**MAINE DEPARTMENT OF
INLAND FISHERIES AND WILDLIFE**

ADDENDUM NO. 1

**IMPROVEMENTS AT GRAND LAKE STREAM STATE FISH HATCHERY
GRAND LAKE STREAM, MAINE**

BGS PROJECT NO.: 3289-14

UPPER PAVILION EXTERIOR ELEVATIONS

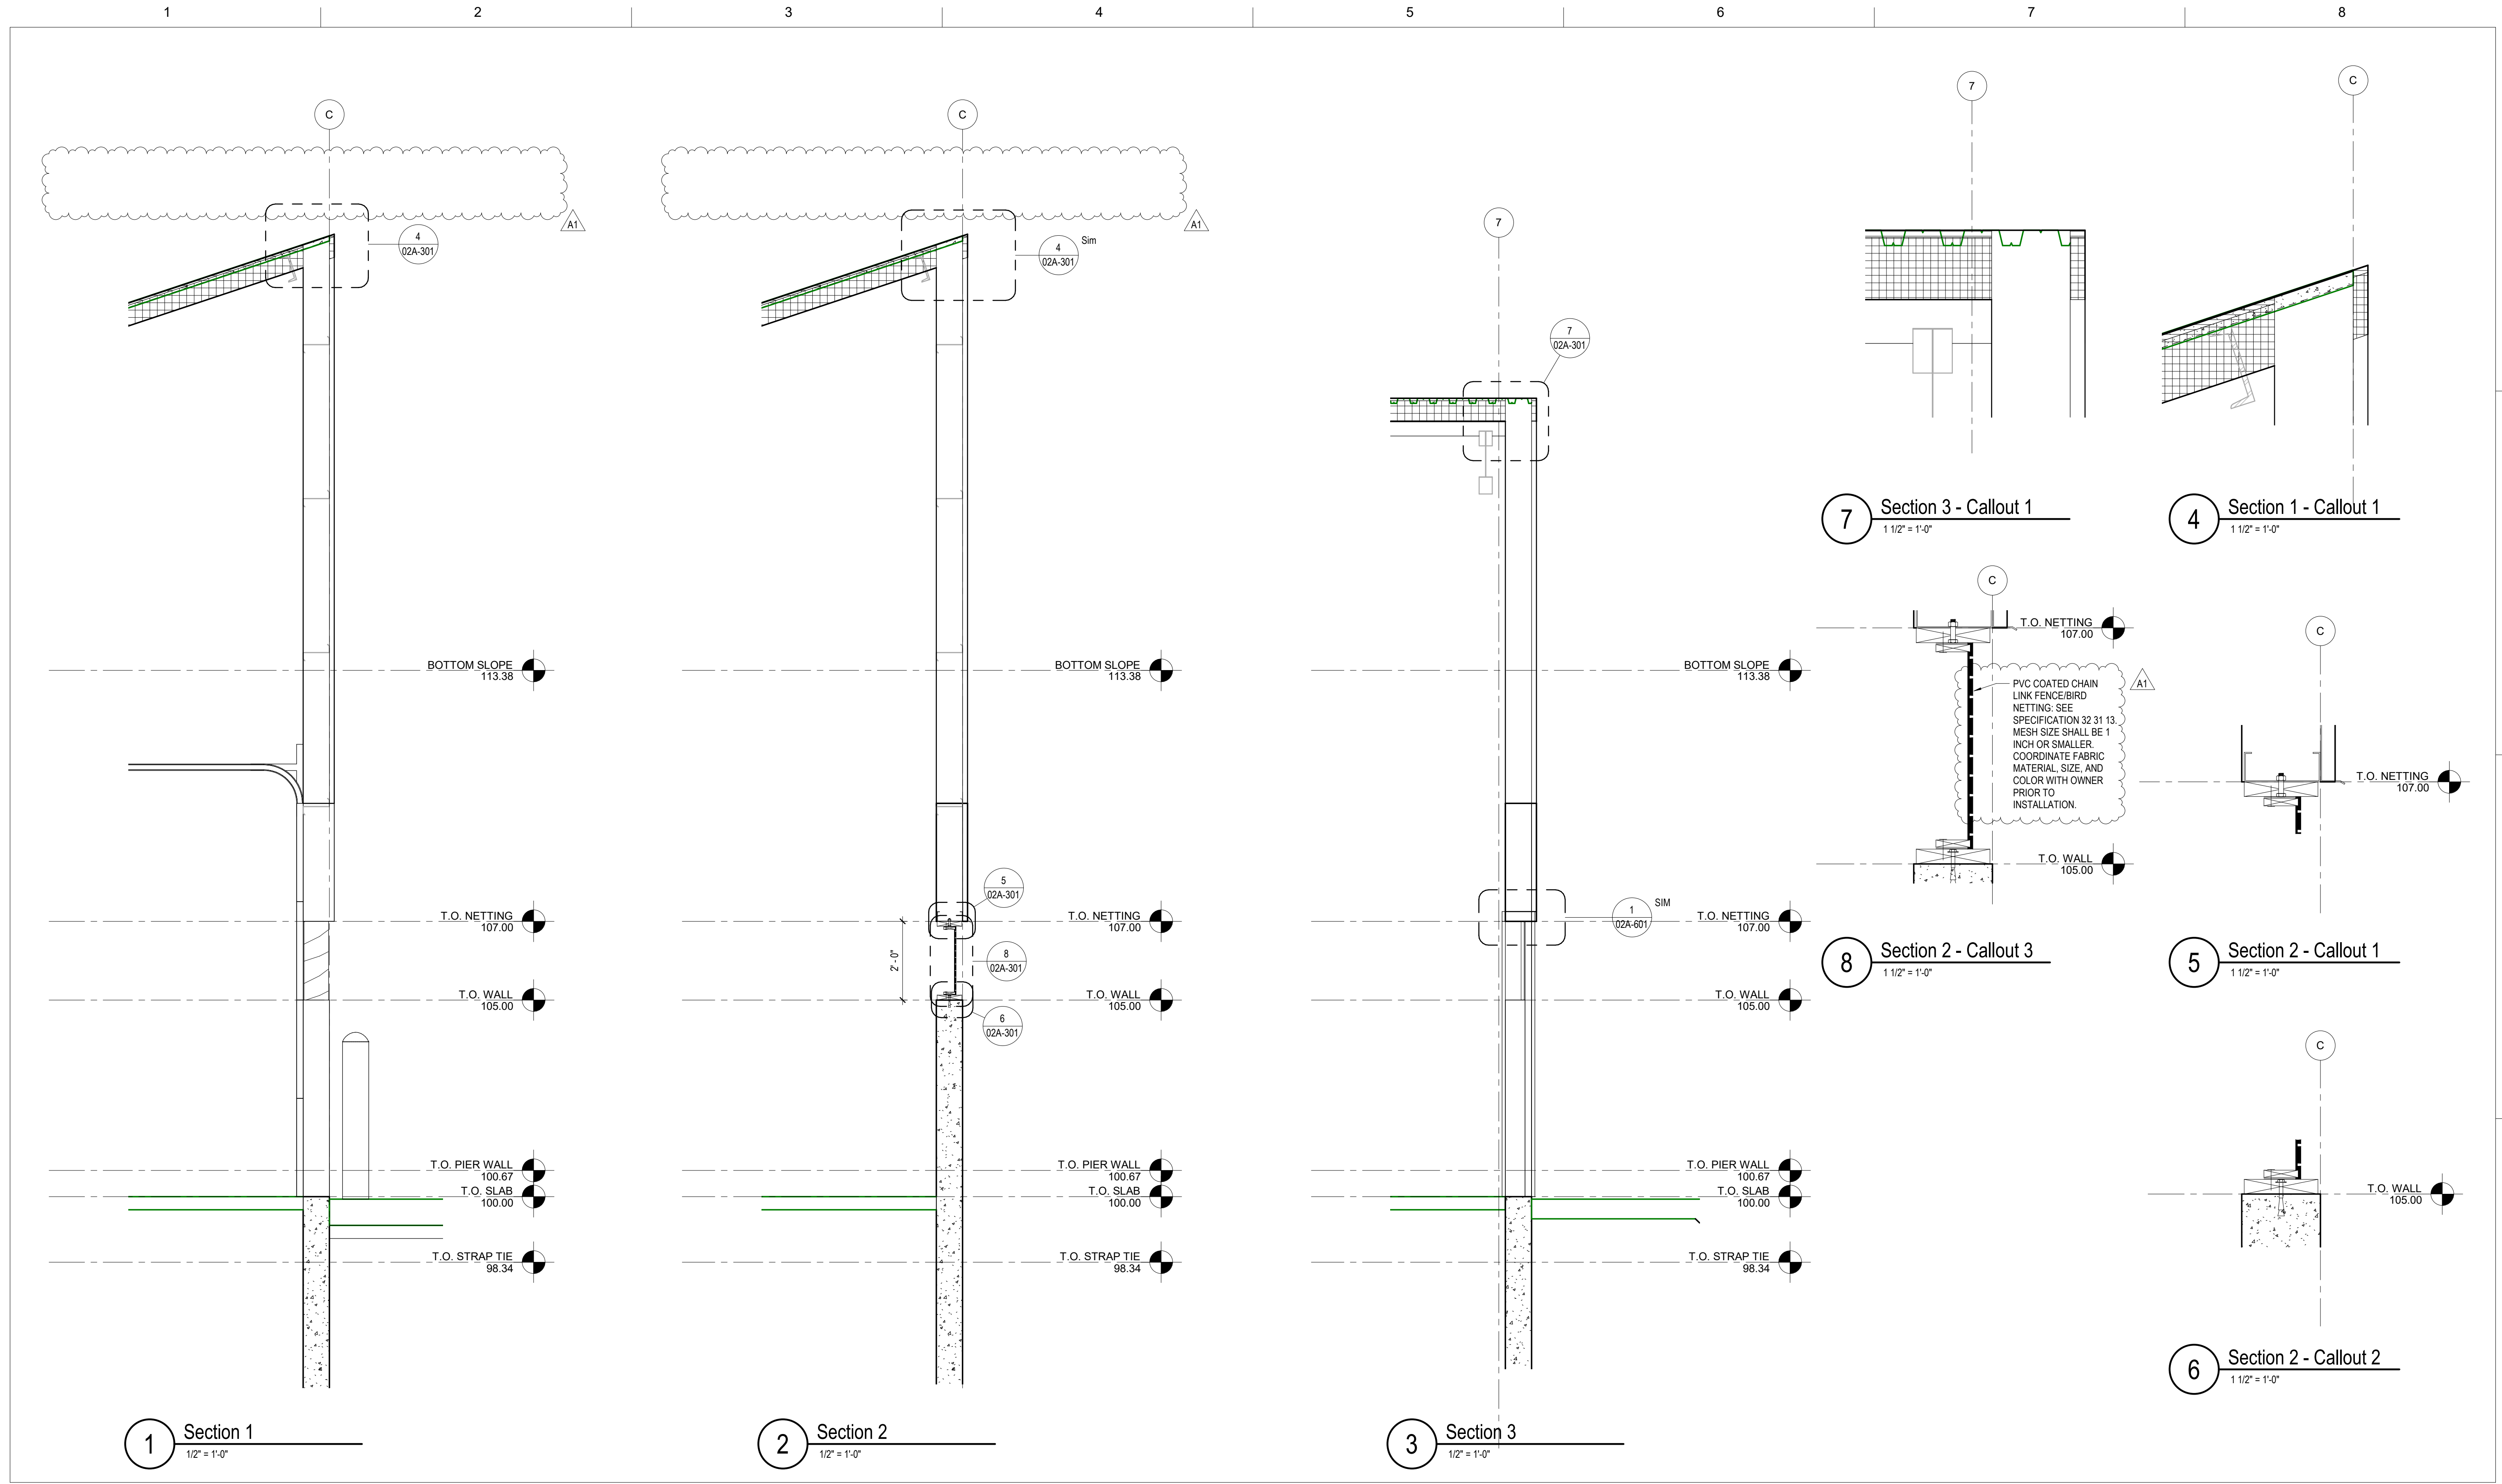
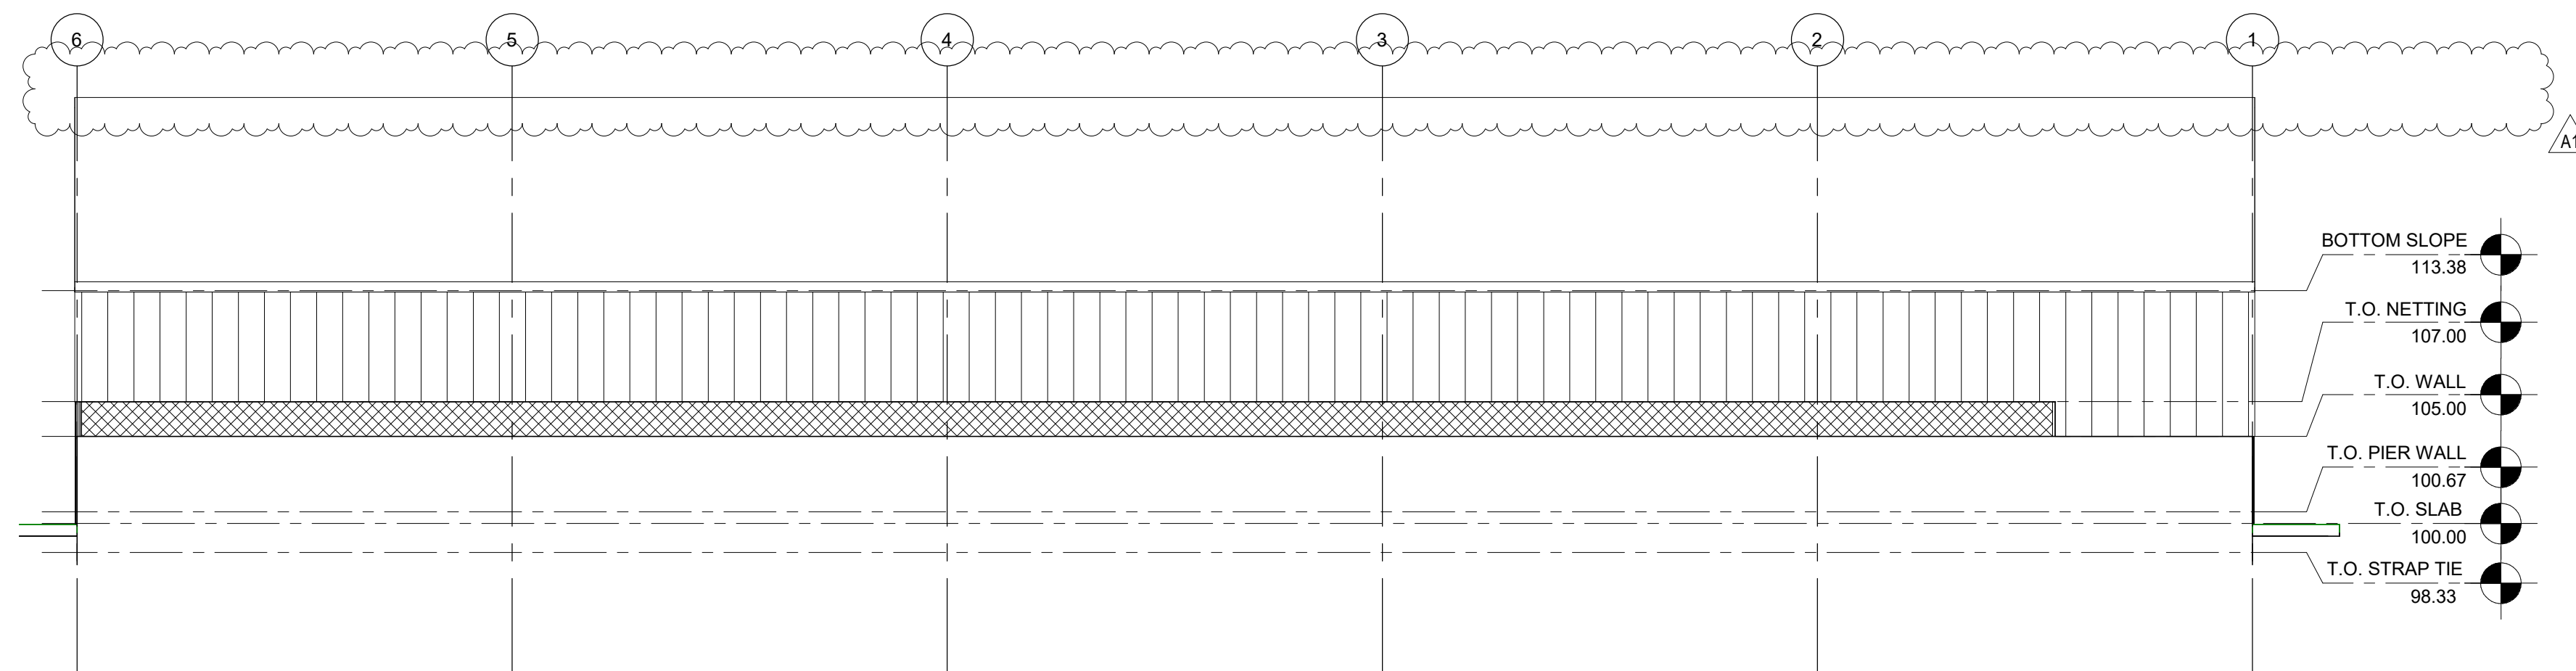
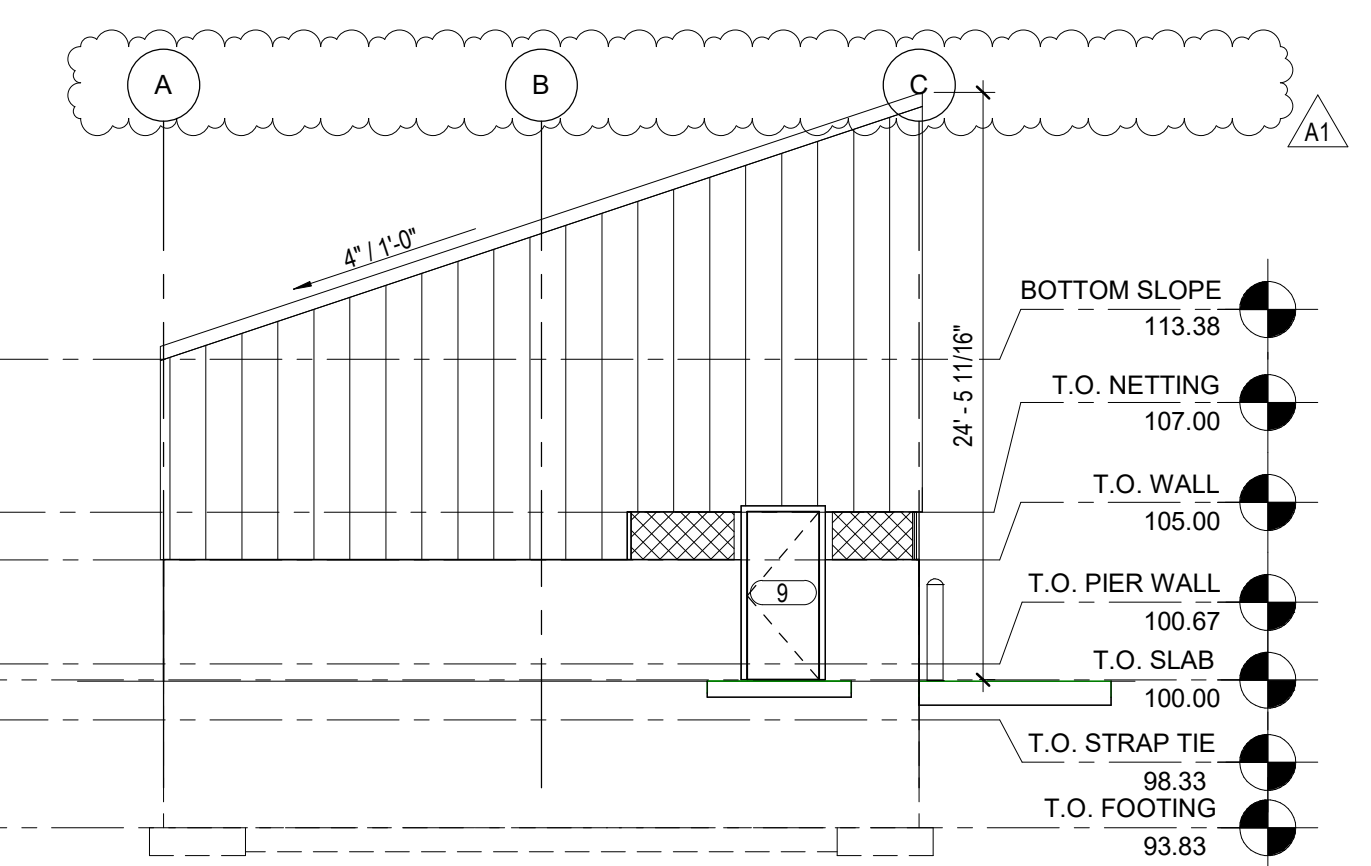
***UPDATE:** Sheet was updated to modify the feed storage garage height to 8-ft.*

UPPER PAVILLION WALL SECTION & DETAILS

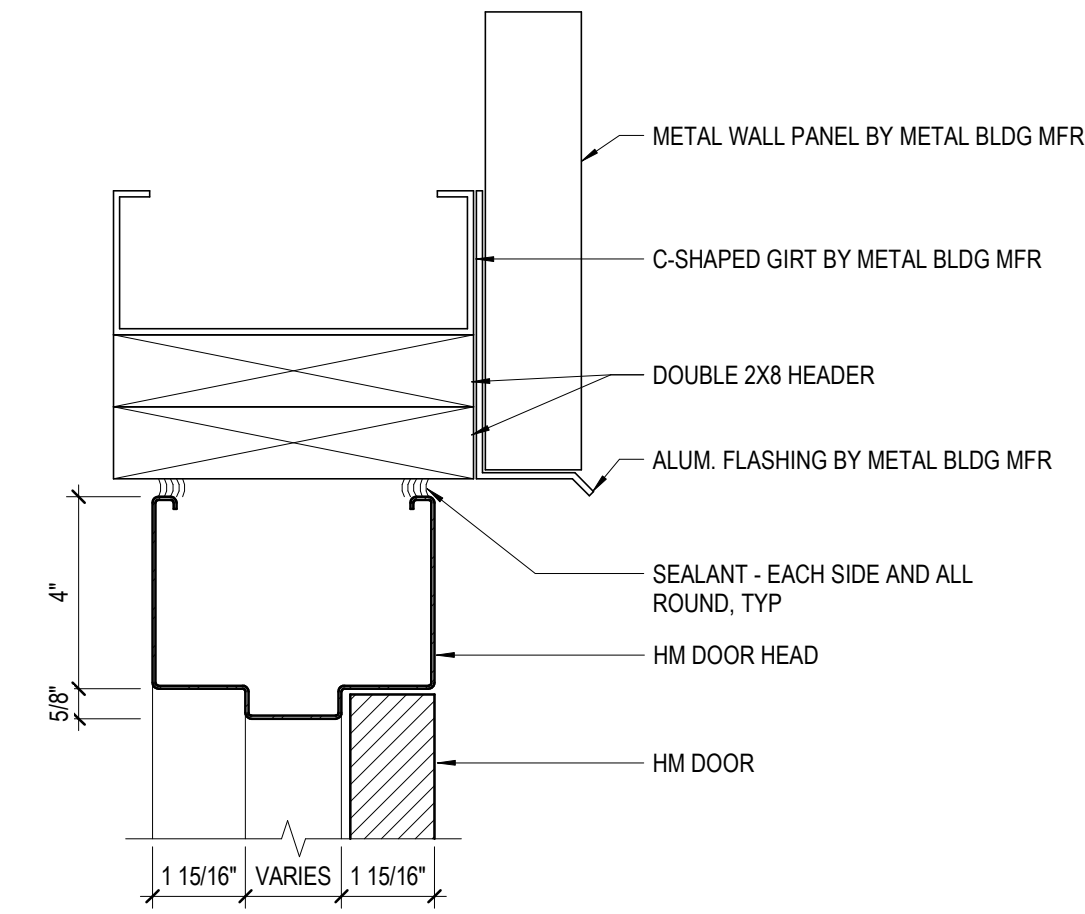
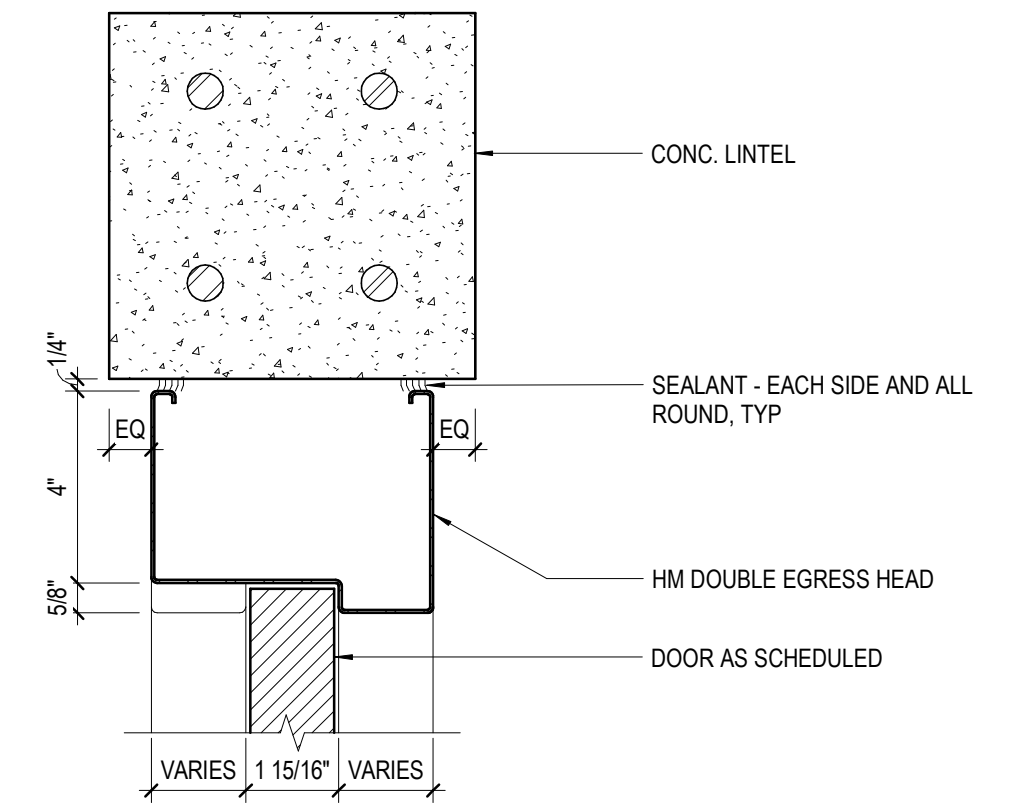
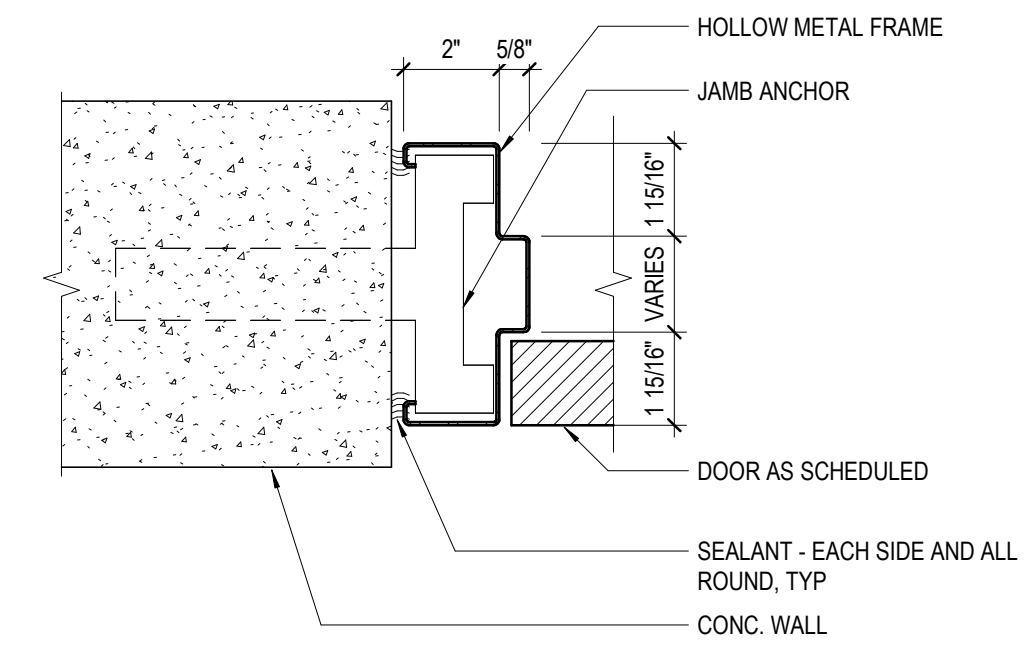
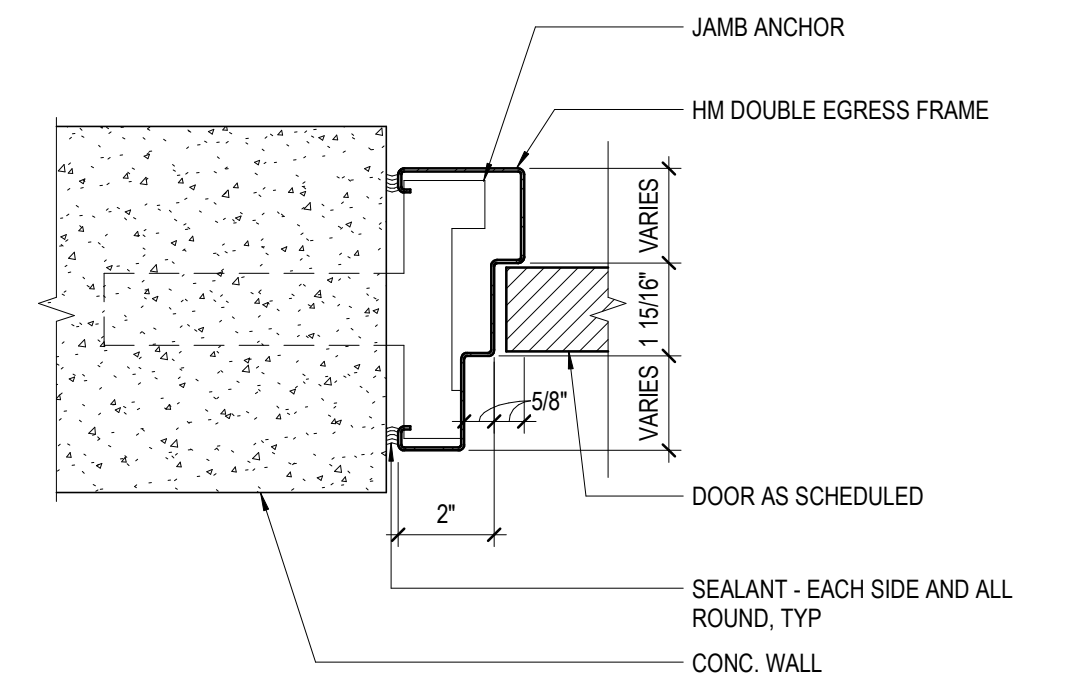
***UPDATE:** Sheet was updated to modify the callout for the bird netting.*
